Addendum No. 3

**Final Environmental Impact Report
for Metro Gold Line Foothill Extension - Azusa
to Montclair (SCH 2010121069)**

**Evaluating Minor Design Changes of the Project
Azusa to Montclair**

Metro Gold Line Foothill Extension Construction Authority
March 2016

Figure 2: Ada Avenue Intersection

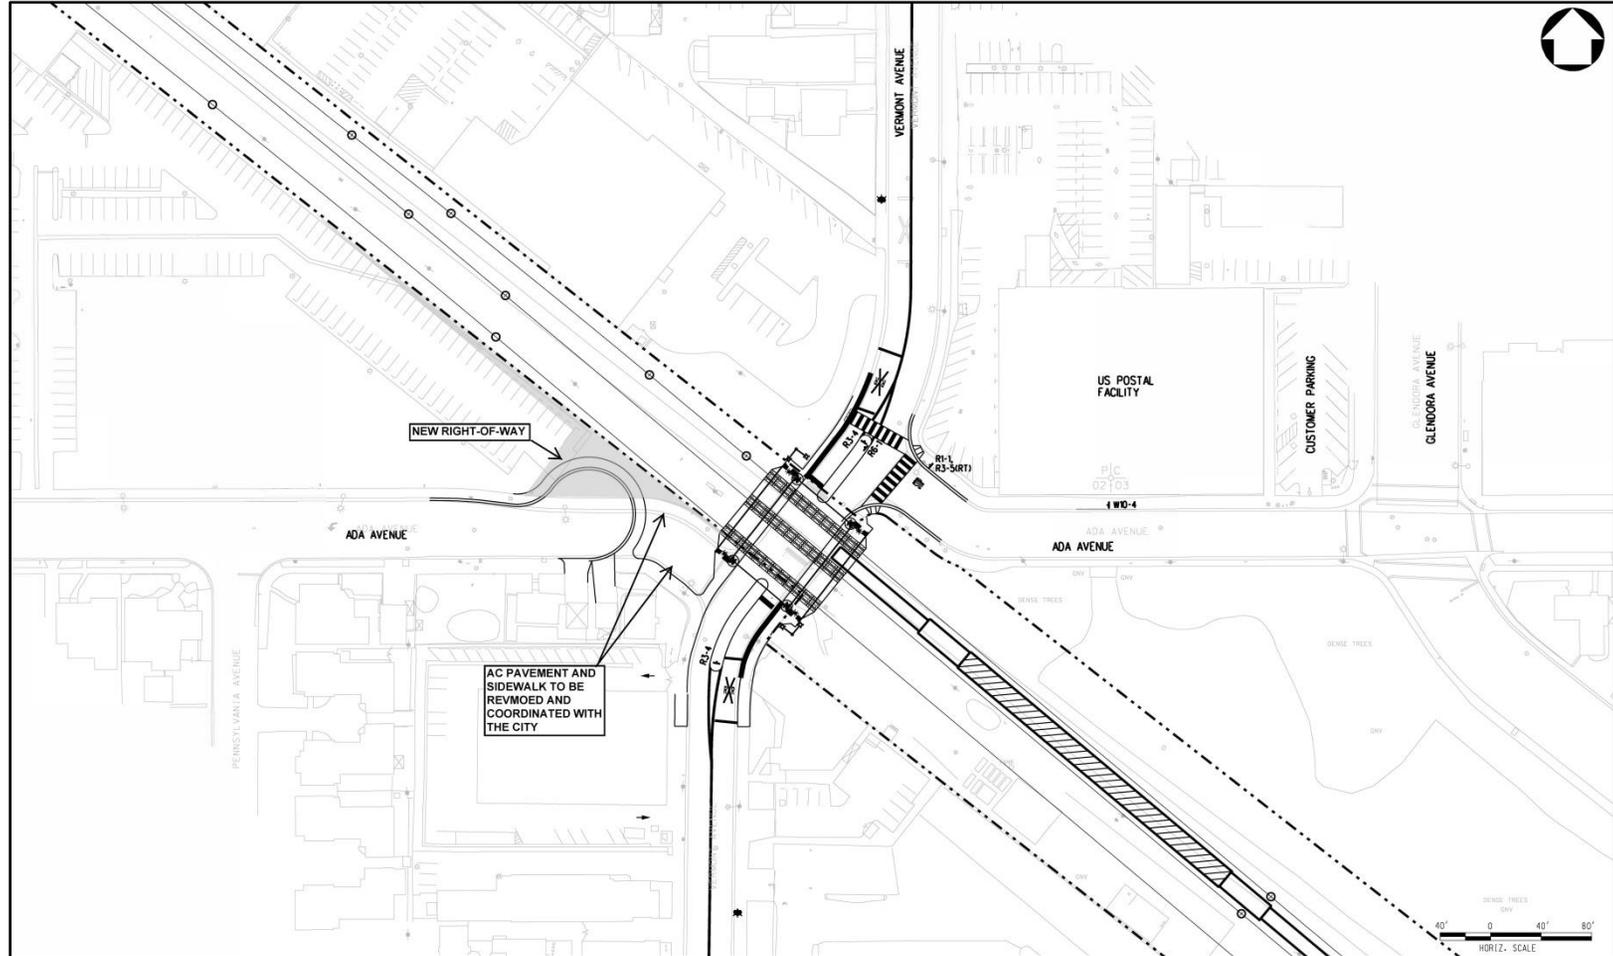
- Modifying access along Ada Avenue in Glendora. The west leg of Ada Avenue will be closed and access will be revised on the east. An illustration of the closure and revised access is provided in Figure 2.

As part of the Project Modifications, the connection of West Ada Avenue to Vermont Avenue will be closed in order to accommodate the grade crossing at Vermont Avenue. Analysis of traffic operations was completed to assess four alternatives to determine the preferred traffic circulation to mitigate impacts from the closure. The recommended Project Modifications on East Ada Avenue would restrict westbound movements to right-turn only and prohibit southbound left-turn movements from Vermont Avenue onto East Ada Avenue. Due to the lower traffic volumes on West Ada Avenue, a level of service (LOS) analysis demonstrates that the closure and other proposed modifications are not anticipated to produce any new significant impacts at the associated intersections. Table 2 and 3 below provide the LOS and delay analysis conducted for the intersection at Vermont Avenue and Ada Avenue, for the AM and PM peak hour periods, respectively.

Figure 3a: La Verne Parking Structure (overview)

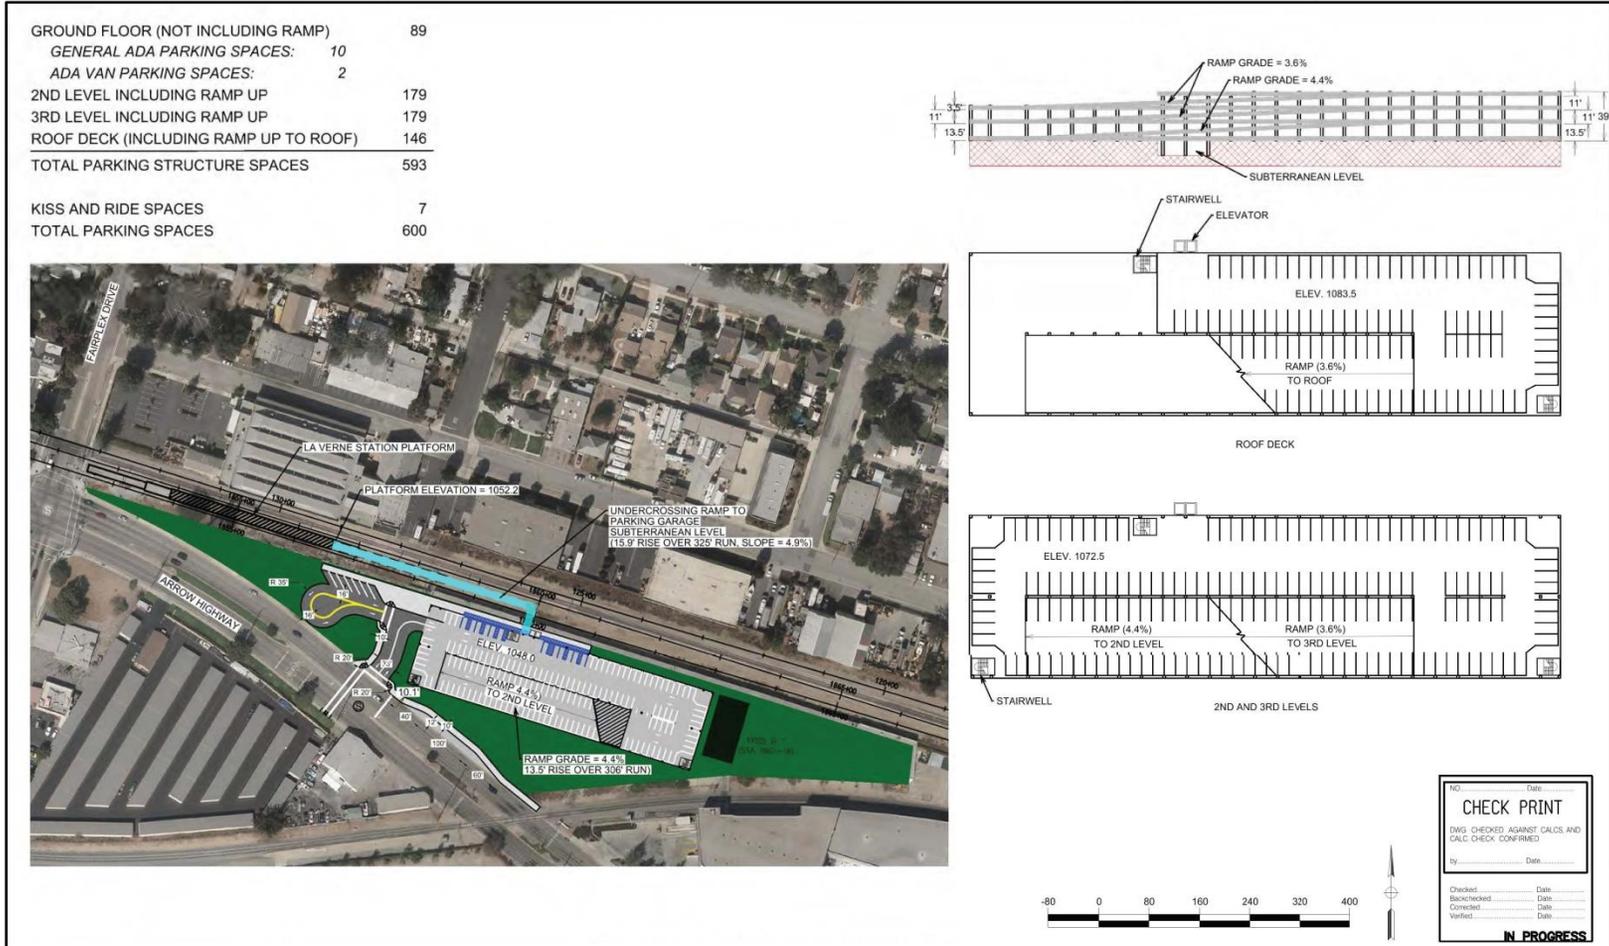
- Modifying the La Verne parking structure from a six-level structure approximately 55 feet above grade to a three-level structure approximately 40 feet above grade. The total number of available parking spaces would remain the same as in the FEIR at 600. Pedestrian access from the parking structure to the La Verne LRT station would be via a pedestrian underpass instead of at grade over the LRT tracks as described in the FEIR. Vehicular access to the parking structure would continue to be provided from Arrow Highway at the same access location as indicated in the 2013 FEIR. The revised site plan for the La Verne parking structure and station access is provided in Figures 3a and 3b.

The Project Modifications would change the La Verne parking structure from a six-level structure, approximately 55 feet above grade, to a three-level structure approximately 40 feet above grade. The total number of available parking spaces would remain the same as in the FEIR at 600. The transportation impacts include modified pedestrian access from the parking structure to the La Verne LRT station, which would be via a pedestrian underpass instead of at-grade over the LRT tracks as described in the FEIR. The primary access/egress point for vehicular traffic off of Arrow Highway will remain the same. The revised site plan for the La Verne parking structure and station access is provided in Figures 3a and 3b above.

The proposed La Verne Station parking structure modifications would lower the overall height of the structure while extending its horizontal footprint eastward. The parking structure would, therefore, be relatively closer to the residences along 1st Street near White Avenue than the Approved Project, but would be lower in scale than the current Approved Project. In addition, the location where the parking structure would be located is currently developed as a large industrial building, and the parking structure would be further away from the residences than existing development. These residences do not have any scenic views looking southward which would be blocked by the garage, and the parking structure would not change the existing railroad and industrial character of the area. The parking structure would be lower than the Approved Project, would be lower than the maximum allowable height permitted by the City of La Verne, and would blend in with future development envisioned for the area.

Figure 3b: La Verne Parking Structure (pedestrian undercrossing)

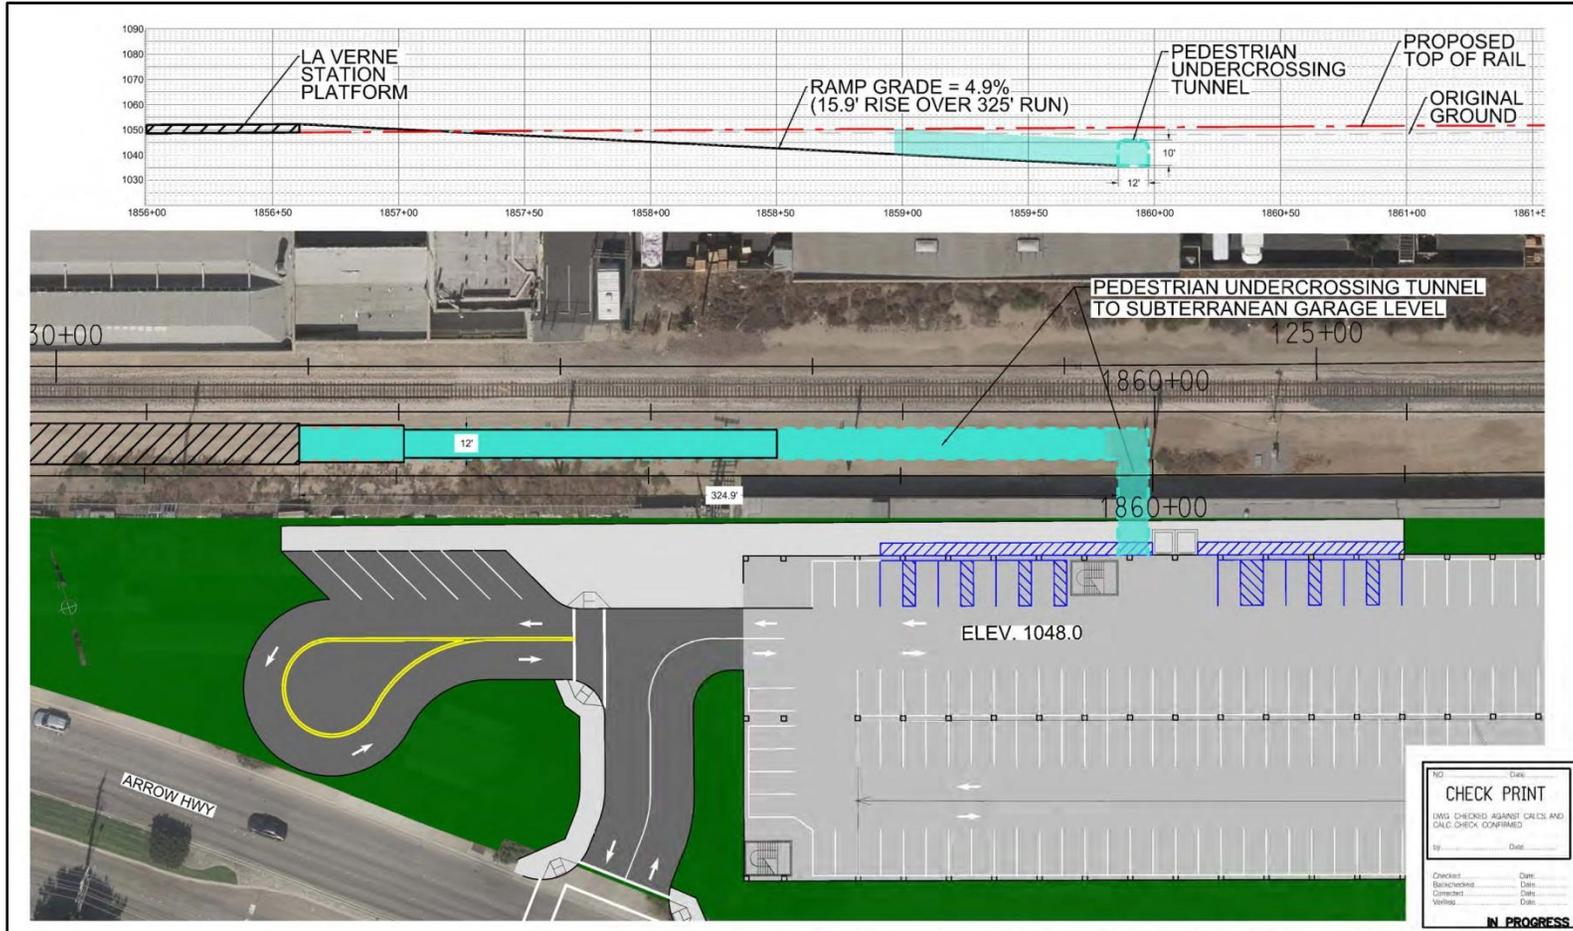
Project Modifications at the La Verne parking structure will incorporate a pedestrian underpass connection between the parking structure and the station. The underpass will eliminate the need for
